**MINUTES OF  
THE PLANNING AND ZONING COMMISSION  
FEBRUARY 13, 2013**

**IV. Site Plan: Review of Gaming Room Addition: Applicant Robert Abner.**

**TO:** Town of Chesapeake Beach Planning Commission  
**FROM:** Christopher Jakubiak, AICP  
Town Planning and Zoning Administrator  
**DATE:** February 12, 2013  
**RE:** **Site Plan, Abner's Addition**

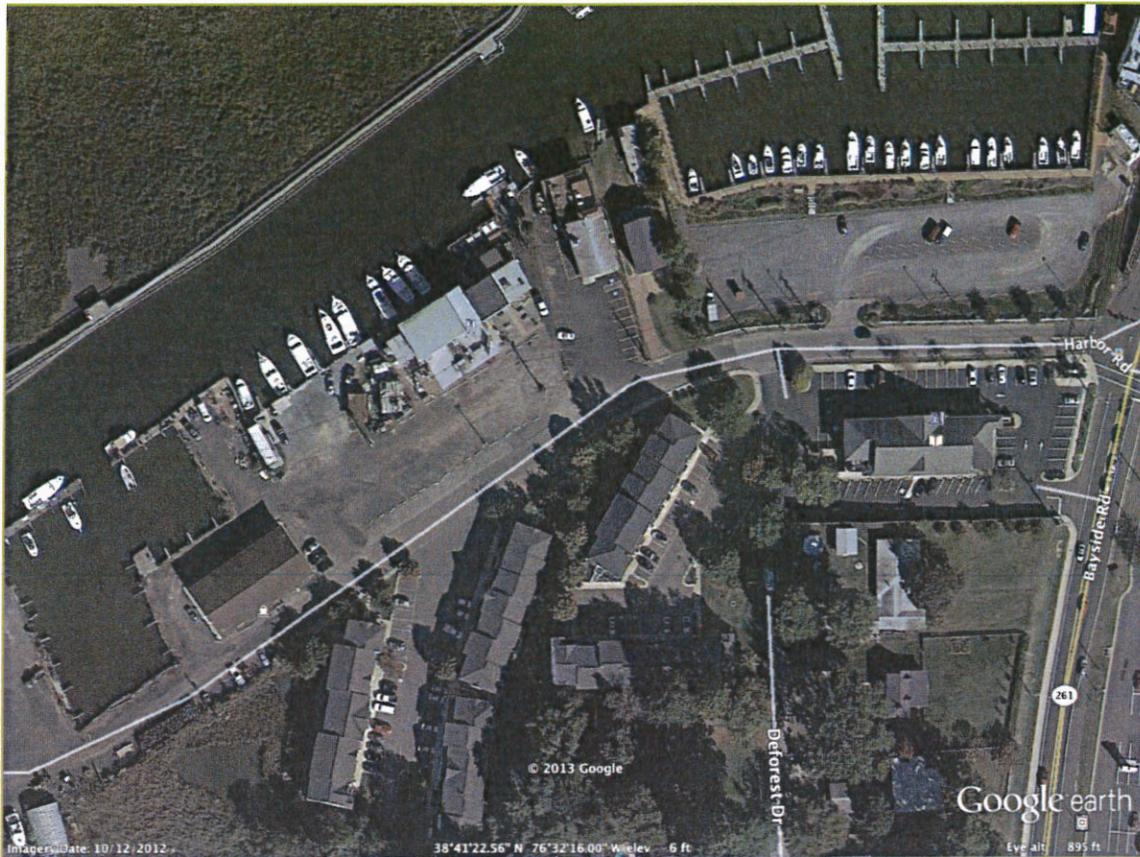
Mr. Robert Abner has submitted a site plan for an addition to the existing Abner Crab House (a copy of which was mailed to each of the Planning Commission members). The property is located on Harbor Road and borders Fishing Creek. It is zoned Maritime. An areal photo of the existing site is shown below.

Site Coordination - FIRST FLOOR PLAN - New Gaming  
 1/18" = 1'-0"

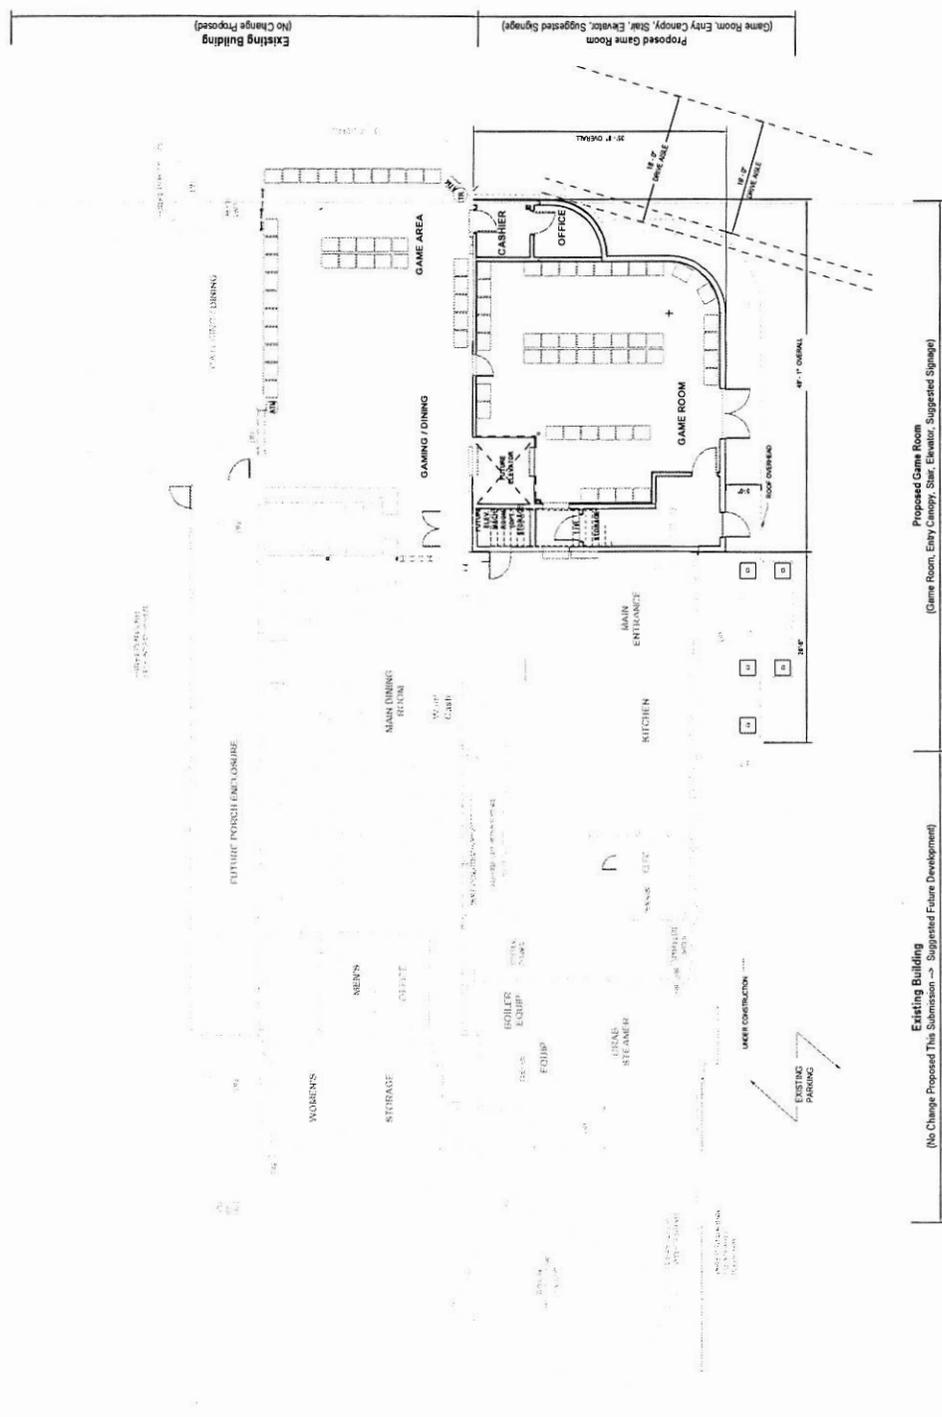
The developer will meet the parking requirements of the ordinance even with the reductions in the proposed number that would result through adherence to the conditions pertaining to landscaping noted below. The exception is bicycle parking. The site plan will need to be revised to show a bike parking rack.

4. On the revised site plan, the applicant shall include the following revisions: (a) Make all the parking spaces 9 feet wide as required by Code. (b) Improve the intersection of the adjoining new parking lot with Harbor Road through use of curbing and landscaping. (c) Provide that all handicapped parking spaces are compliant with the federal ADA and the Maryland accessibility code and/or regulations. (d) Incorporate a landscape screening hedgerow and/or approved fence in the space between the public right-of-way of Harbor Road and the edge of the parking lot, which landscaping area shall be at least 15 feet wide. This will necessitate the removal of the proposed parking spaces located closest to Harbor Road: in the southeast and southwest corners of the parking lot

5. The site plan does not yet meet the requirements that parking for bicycles be provided. The plan should therefore be amended to locate a bike parking facility per the Town Zoning Ordinance.
